RE: **Lot 27 Block 6 Unit 22, S.A.D. 228**
Volcano Cliffs Subdivision
6201 Papagayo Rd. NW
Grading and Drainage Plan
Engineers Stamp Date 11/17/2020 (D10D003B27)

Based upon the information provided in your submittal received 3/30/2020, this plan is approved for Grading Permit.

MAGEE — GRADING & DRAINAGE PLAN

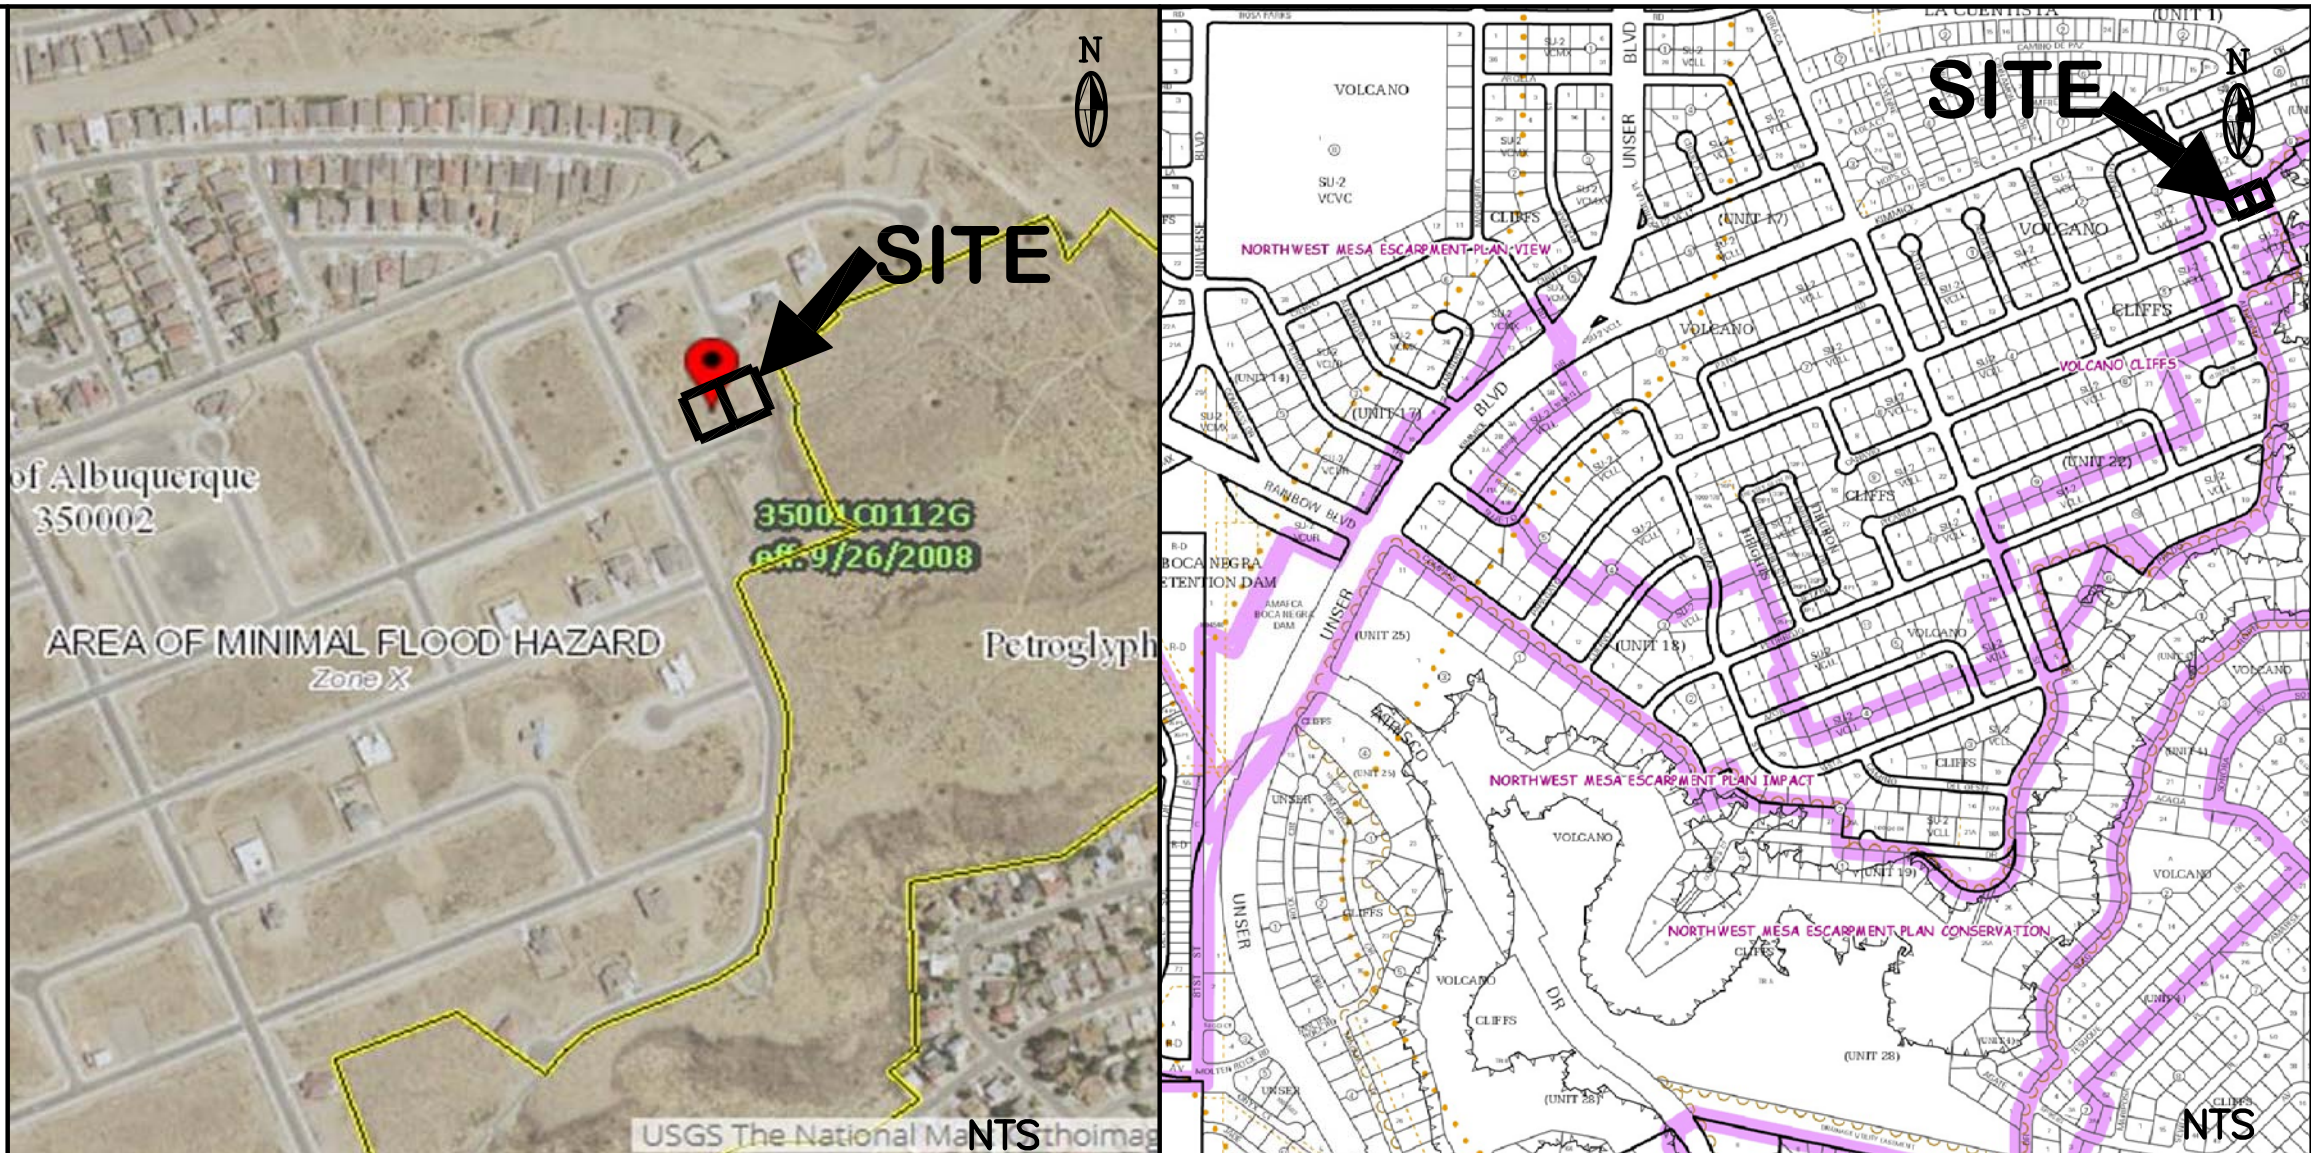
Prior to Building permit approval a Pad Certification will be required, provided by the Engineer or a registered Land Surveyor.

Please inform the builder/owner to attach a copy of this approved plan to the construction sets in the permitting process prior to sign-off by Hydrology.

Reiterate to the Owner/Contractor that a separate permit for a garden/retaining wall must be obtained, with the approved G&D plan dated 7/28/2020. **Also notify the GC or owner not to use dirt in the right of way, lumber of crusher fines are acceptable.**

Prior to Certificate of Occupancy release, Engineer Certification per the DPM checklist of this plan will be required.
